# Connecticut Work Zone Reviews

## Annual Report

# 2015

State of Connecticut  
Department of Transportation  
Office of Construction

**TRAFFIC PLAN THAT SHOWS THE USE OF TRAFFIC DRUMS ON THE TANGENT OF LANE CLOSURE AND THE USE OF DRUMS AND/OR CONES AROUND THE WORK AREA**

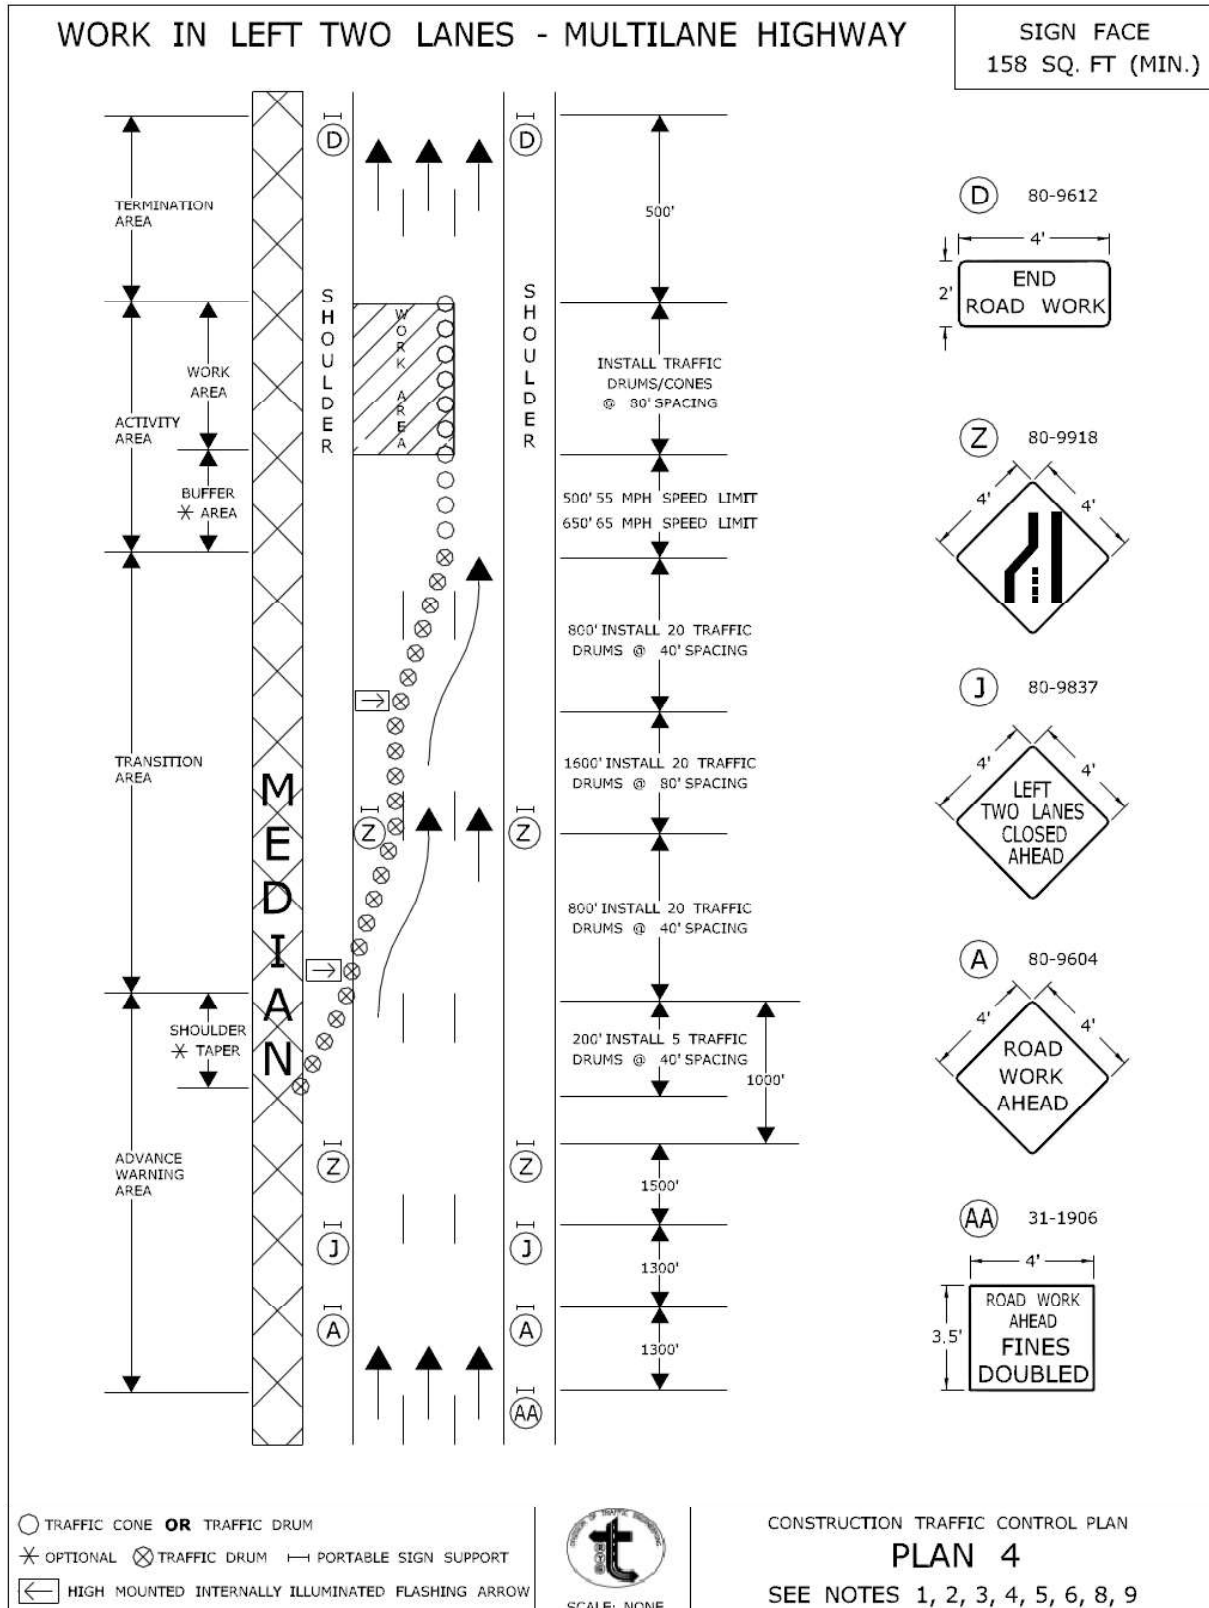
*The Chief Inspector had concern with the typical traffic plans in the M&PT calling for the use of only traffic drums for lane closures. PLAN 4 calls for the use of traffic drums on the transverse and on the tangent as well. The MUTCD lays out traffic drums on the transverse and traffic cones on the tangent. According to him, when taking a lane, especially on a curve, and using just drums driver's sightline is misled when transitioning from the one lane closed to two lanes closed. By the time the driver realizes that the second lane is closed and traffic is merging, they end up hitting the drums before merging over properly. In order to transition from a one lane closure to a two lane closure, the traffic pattern can extend 3000 feet from beginning of pattern to the end. He would like to have the option of using cones on the tangent of the closed lane. (See attached traffic plan and notes.) The Office of Traffic said that the motorists may think the transition is over if the traffic drums are replaced with traffic cones within the transition area. Unless there are other reasons why traffic drums should be replaced with traffic cones, Traffic recommends that the traffic control plans are to be followed as shown in the M&PT special provisions.*

# REVISED DETOUR PLAN FOR EXIT 12 OFF RAMP CLOSURE

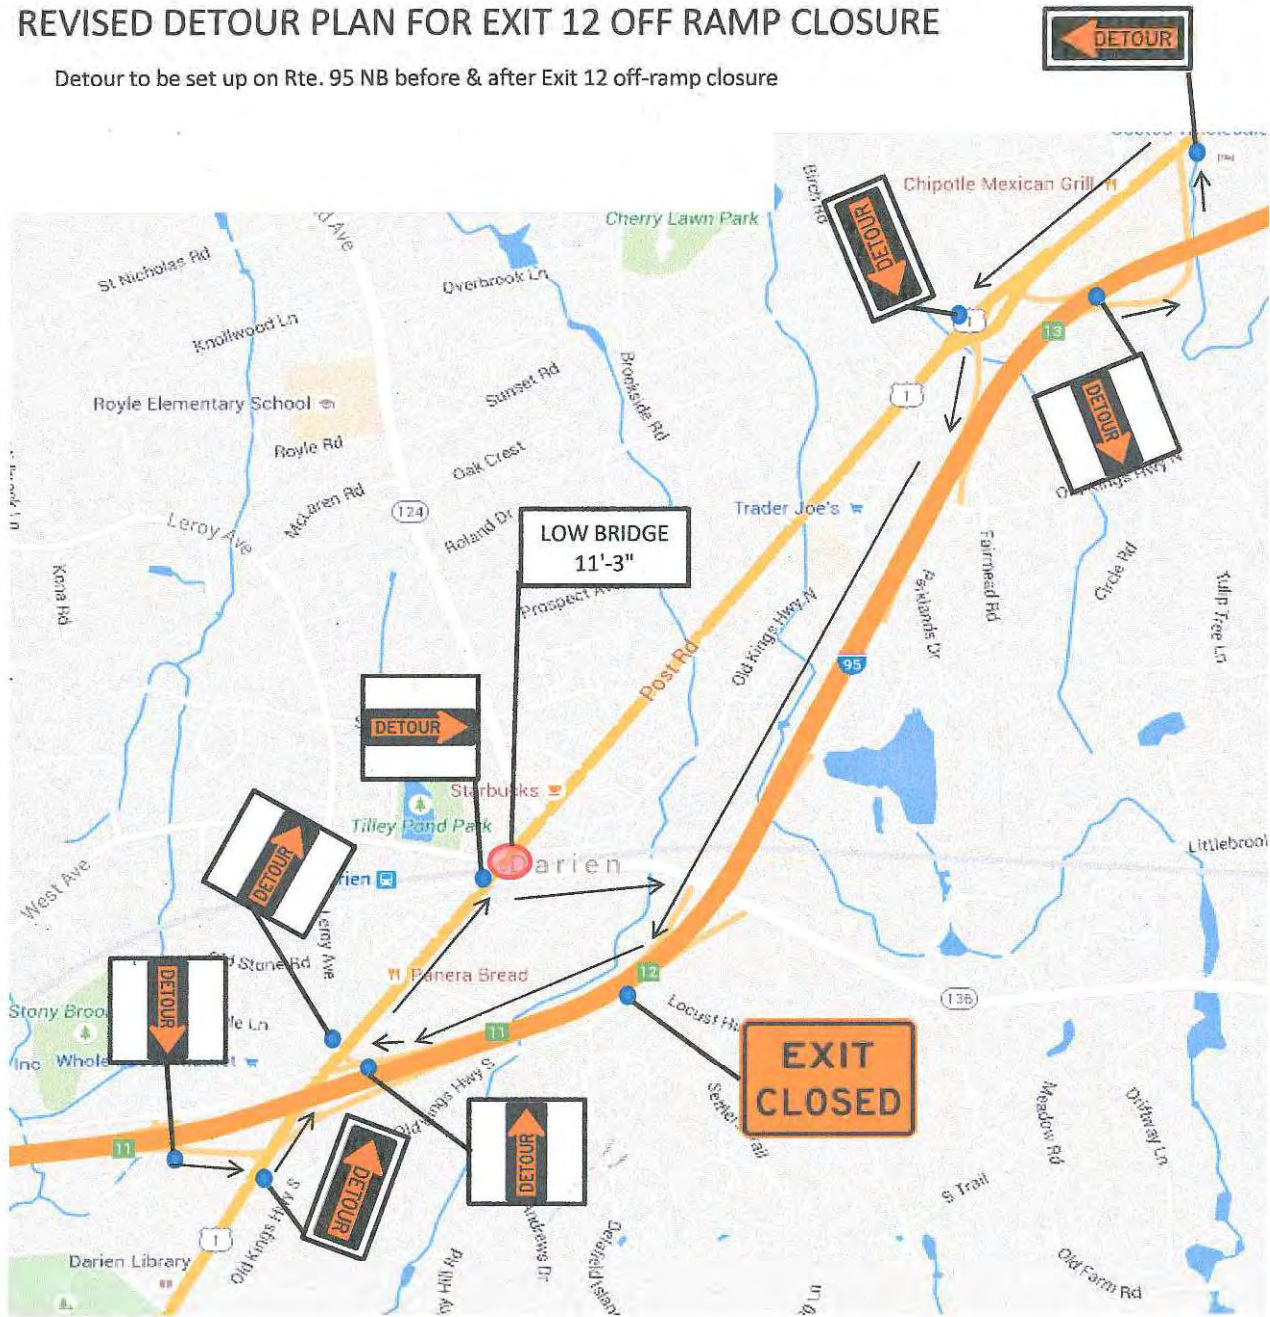
*The project had an issue with the suggested detour plans for the ramp closures. Some of the detours rerouted traffic under bridges with heights 11 feet high like Northbound Exit 12 off ramp detour. The minimum overpass height for trucks to clear under is 14 feet. The inspection staff revised some of the detours as they've used them and submitted to the District and the District forwarded them to Office of Traffic to inform them of the field changes made.*

3. The Chief Inspector drove the suggested detour route for Exit 12 off-ramp (attached) and had to modify the plans because of a low bridge with posted 11'-3" clearance. This bridge and others on other suggested detours are too low for trucks to clear under.

**NOTE:**  
Specs. Show detour through Low Bridge 11'-3"

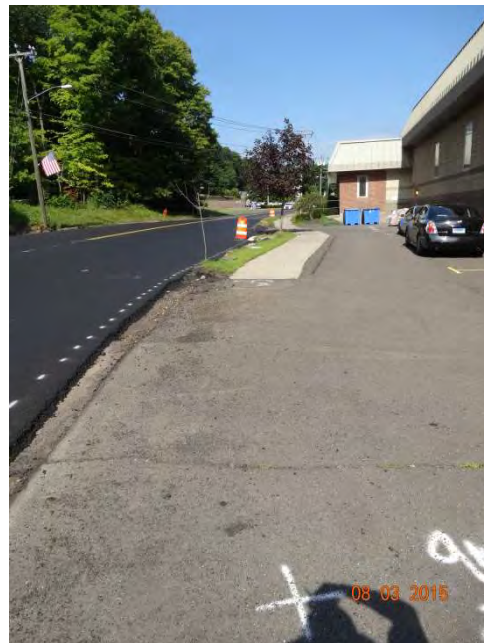
**Route 73 NB: Plywood covering a detectable warning pad. This poses as another unnecessary trip hazard.**

**Route 73 SB: The sidewalk curb lip is higher than the half inch requirement from the roadway. Although this is a new sidewalk on the route, it still needs to meet ADA requirements during construction not just at the finished state.**
